LR-N00-0387  
LCR S00-06

**REQUEST FOR LICENSE AMENDMENT  
INCREASED LICENSED POWER LEVEL  
SALEM GENERATING STATION, UNIT NOS. 1 AND 2  
FACILITY OPERATING LICENSE DPR-70 AND DPR-75  
DOCKET NOS. 50-272 AND 50-311**

**ATTACHMENT 1  
SALEM GENERATING STATION  
UNIT NOS. 1 AND 2  
FACILITY OPERATING LICENSE DPR-70 AND DPR-75  
DOCKET NOS. 50-272 AND 50-311  
CHANGE TO TECHNICAL SPECIFICATIONS  
INCREASED LICENSED POWER LEVEL**

FIGURE 2.1-1  
REACTOR CORE SAFETY LIMIT - FOUR LOOPS IN OPERATION

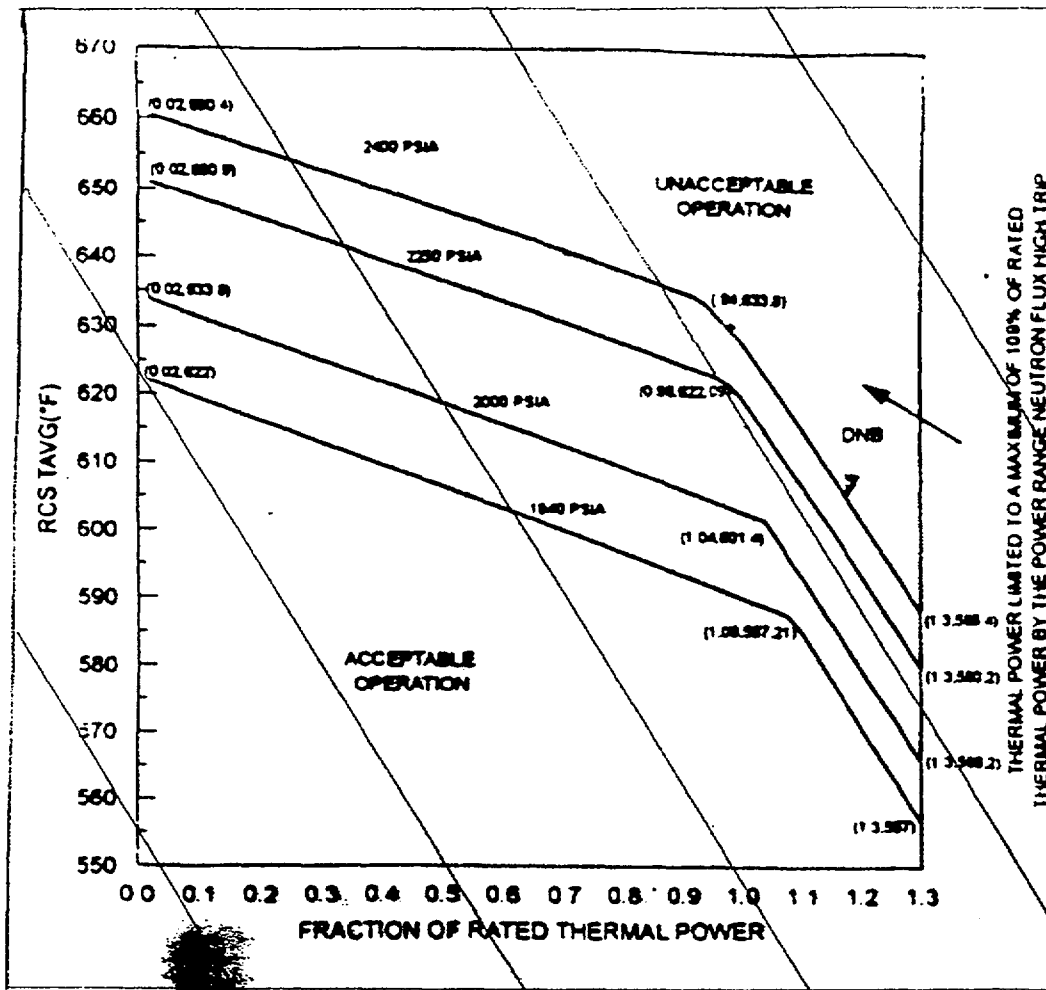
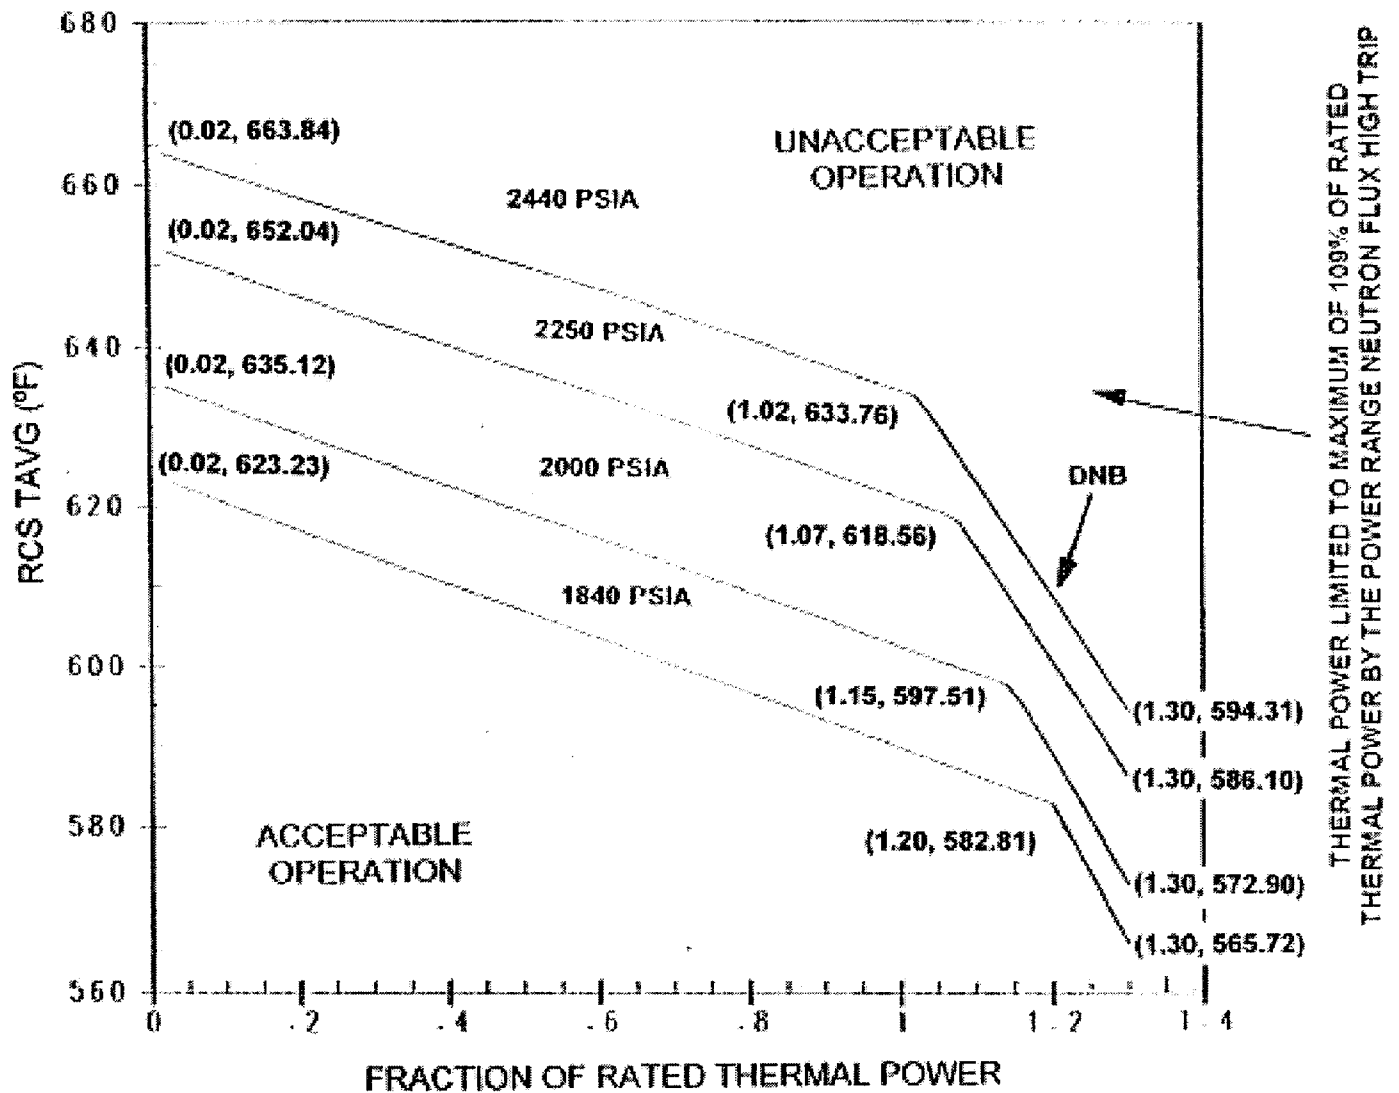
1. Technical Specification Figure 2.1-1, Reactor Core Safety Limit, is revised to reflect the new safety limits required to prevent core exit boiling at the new core power of 3459 MWt.
2. The Overtemperature  $\Delta T$  (OT $\Delta T$ ) f( $\Delta I$ ) penalties in Technical Specification Table 2.2-1, Reactor Trip System Instrumentation Trip Setpoints, are revised to support the increase in core power.

# INSERT A1

Figure 3.4-2. Sales Unit 1 Reactor Coolant System Heatup Limitations

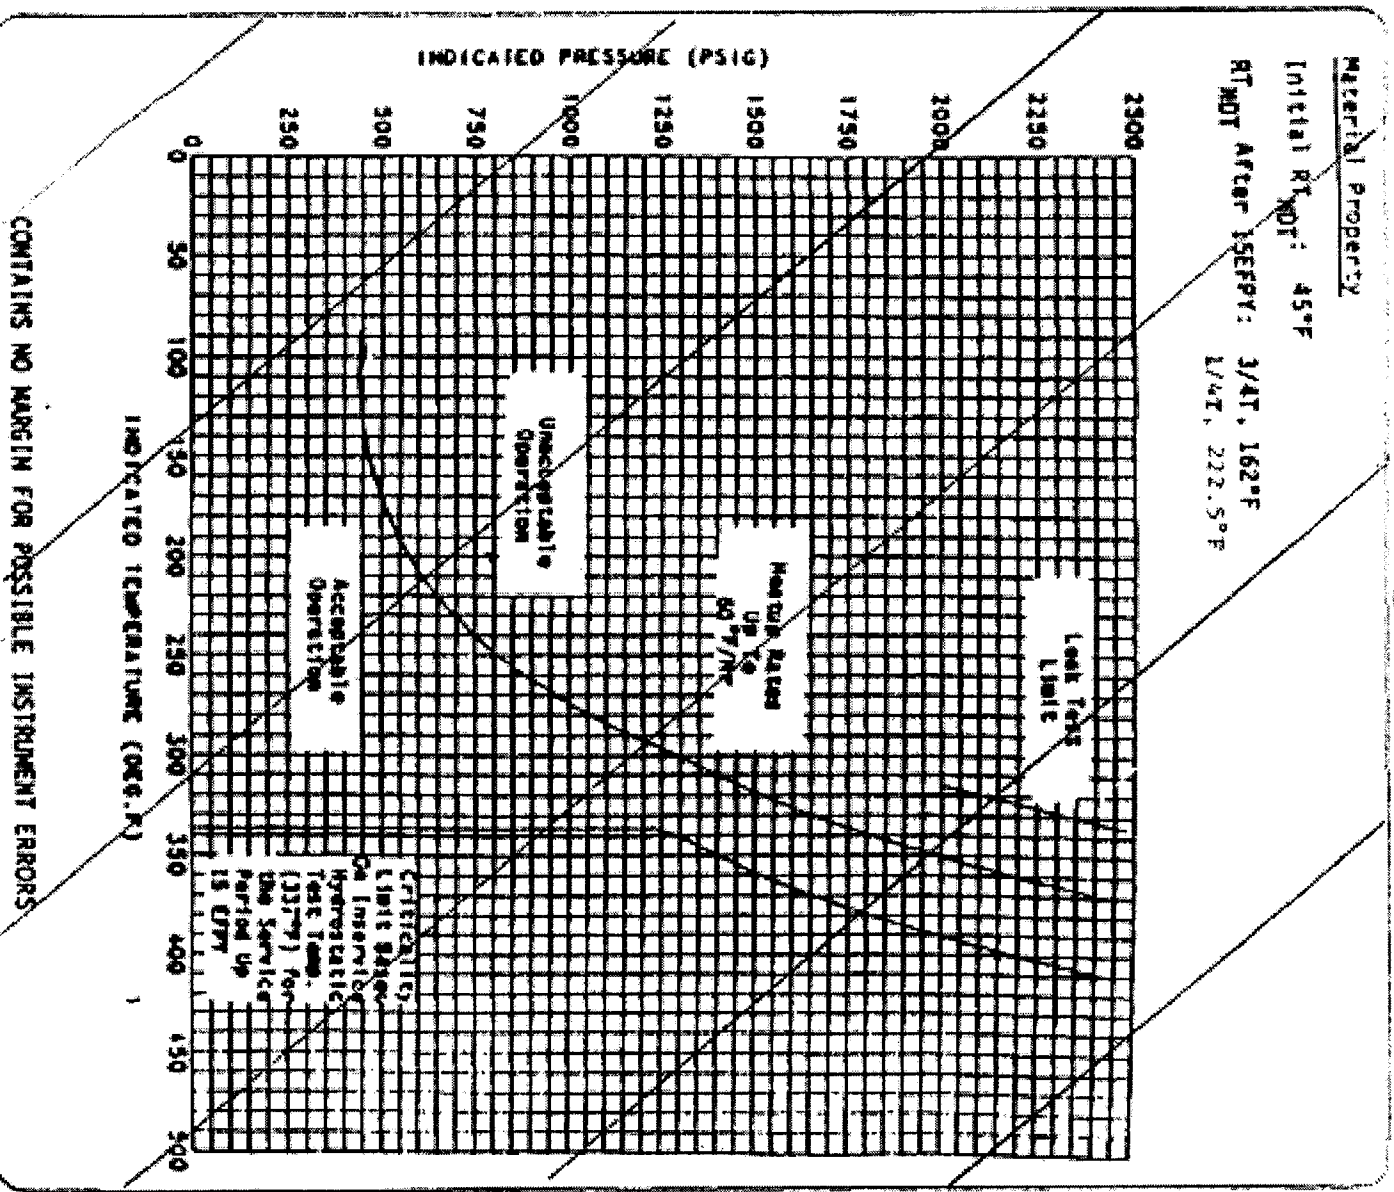
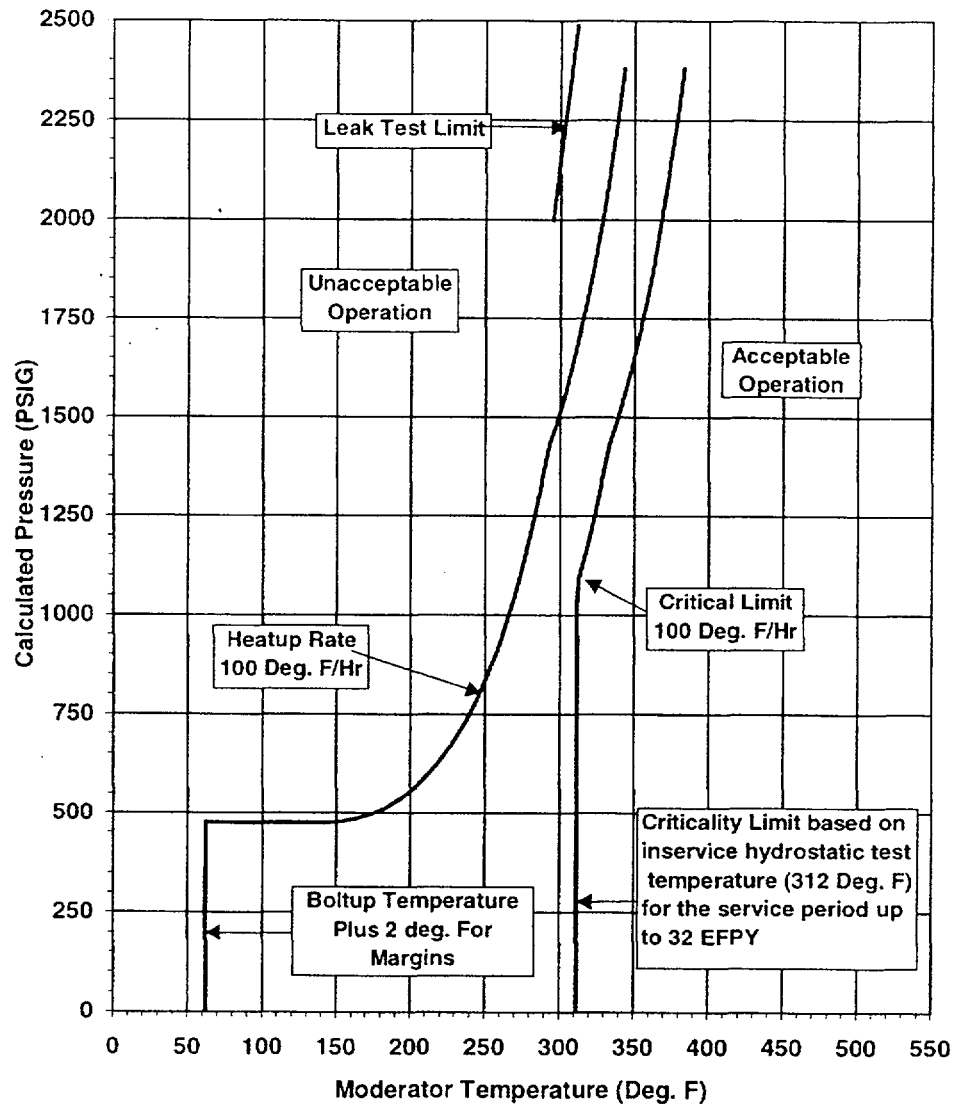
1. Technical Specification Figures 3.4-2 and 3.4-3, Reactor Coolant System Heatup and Cooldown Curves, and their associated Bases are revised to

support the increase in core power based on updated fluence projections. The revised curves are applicable for the service period up to 32 effective full power years (EFPY). The maximum heatup rate for Figure 3.4-2, Reactor Coolant System Heatup Limitations, is being changed from 60°F/hr to 100°F/hr. The revised curves are being adjusted to account for pressure and temperature instrument uncertainties, and the curves are being extended to show minimum boltup temperature. The values in Bases Table B 3/4.4-1, Reactor Vessel Toughness Data, for Unit 1 and 2 are being updated to reflect information related to reactor pressure vessel integrity provided previously to the NRC in response to Generic Letter 92-01 and its supplement.

New heatup and cooldown curves were developed for the Salem Units 1 and 2 reactor vessels based on the uprated fluence projection at 32 effective full-power years (EFPY). The maximum heatup rate for TS Figure 3.4-2 is being changed from 60°F/hr to 100°F/hr. This heatup rate change is consistent with the current Technical Specification LCO 3.4.9.1.a for Unit 1, LCO 3.4.10.1.a for Unit 2, the heatup cyclic limits of TS Table 5.7-1, and the Analysis of Record. The revised curves are being adjusted to account for pressure and temperature instrument uncertainties. Minimum boltup temperature is shown.

# INSERT B1

@1/4T	@3/4T
Initial $RT_{NDT}$	Weld 3-042C	Plate B2402-1
$RT_{NDT}$ after 32 EFPY	-56°F	45°F
	232°F	171°F

Figure B 3/4.4-1 Fast neutron fluence ( $E > 1\text{MeV}$ ) as a function of of full power service life (EPPY)

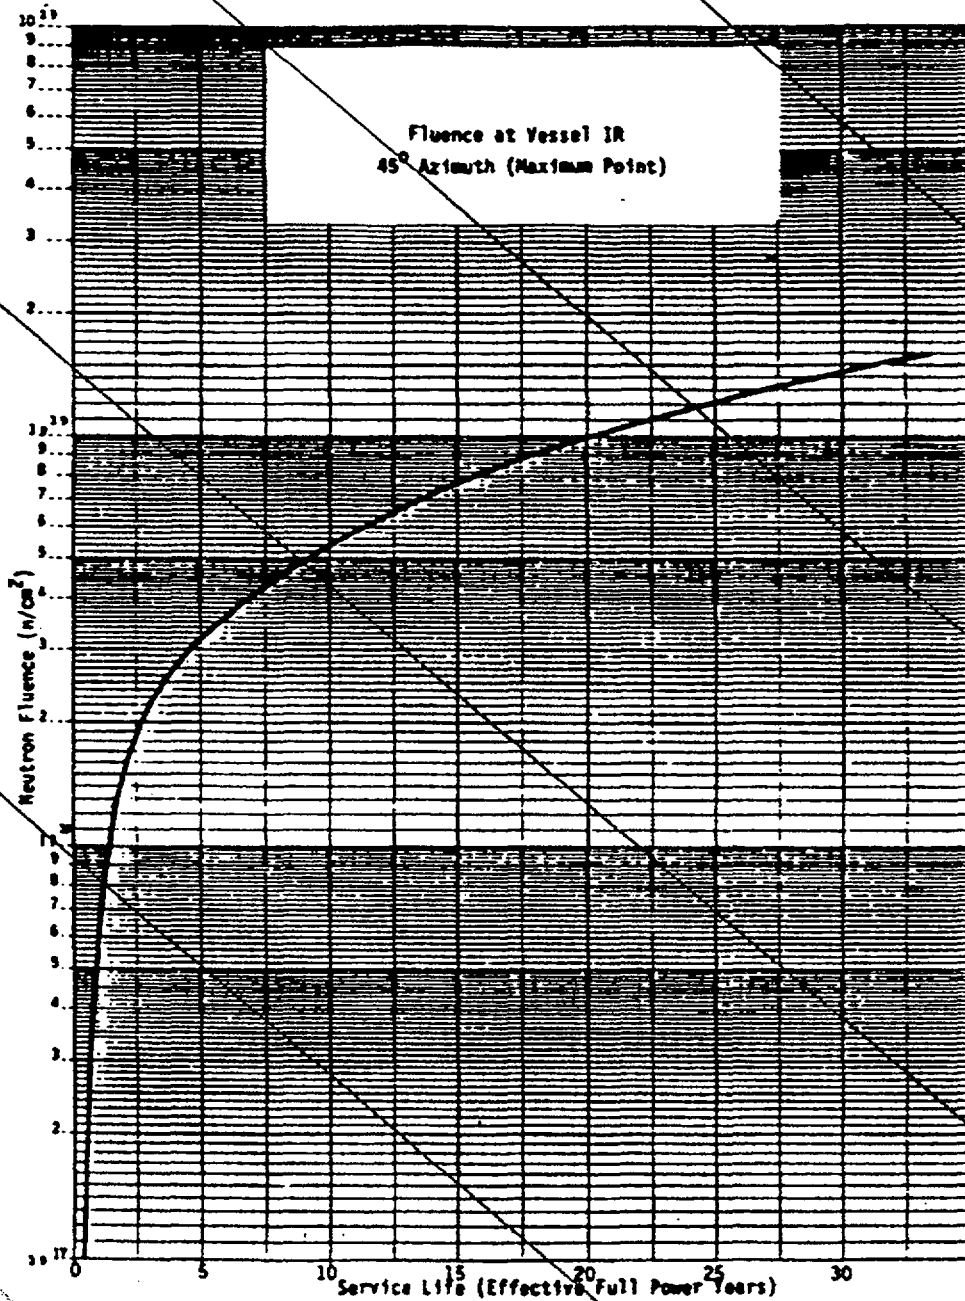
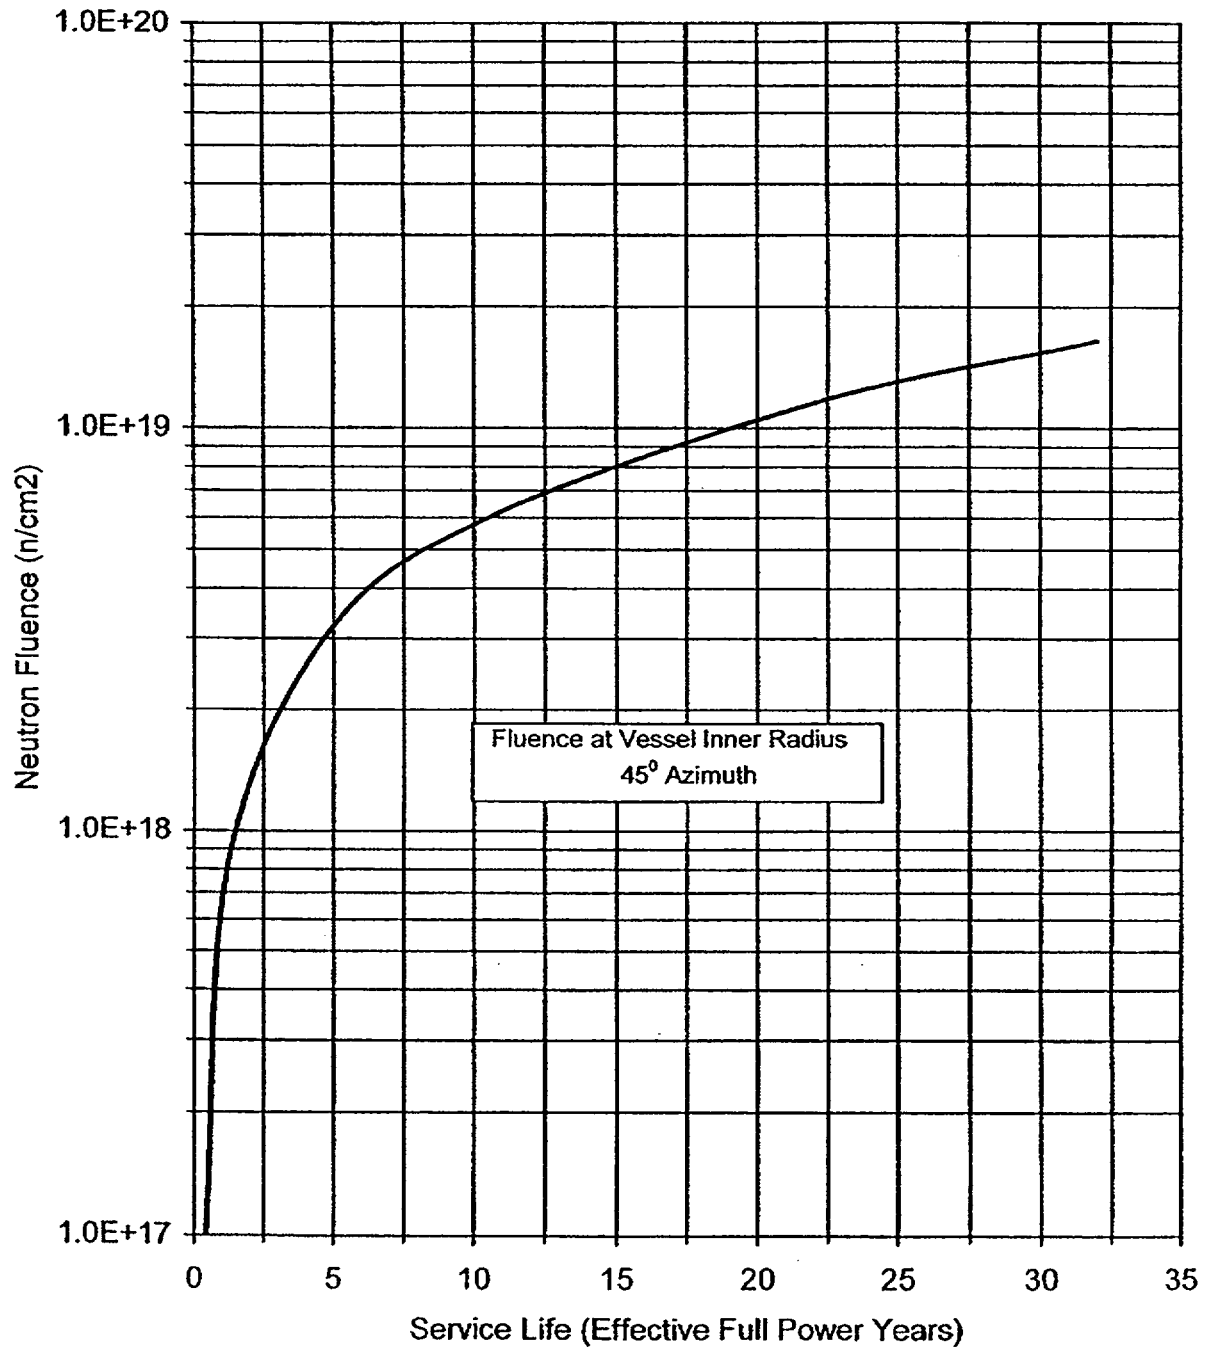
1. In TS Bases 3/4.4.9, references to ASME Boiler and Pressure Vessel Code, Section III, Appendix G are being changed to Section XI, Appendix G which is the correct reference for requirements related to reactor vessel pressure-temperature limits.
2. In TS Bases 3/4.4.9, corrections are being made to the symbol " $\Delta RT_{NDT}$ " in cases where the symbol is represented incorrectly.
3. In TS Bases 3/4.4.9, a reference to Figure B3/4.3-1 is being revised to the correct number, Figure B3/4.4-1.

The results of the fast neutron exposure evaluations for Salem Units 1 and 2 account for the uprated power level. The results are based on the conservative assumption that the power uprate was initiated coincident with the last surveillance capsule withdrawal from each unit. The resulting fast neutron ( $E > 1.0$  MeV) exposure projections increased due to the power uprate. The new projections were used as input to the reactor vessel integrity evaluations. TS Bases Figure 3/4.4-1 shows predicted fluence as a function of Effective Full Power Years. The results of the fast neutron exposure evaluation are incorporated in the revised figures in Attachment 4.

# INSERT E1
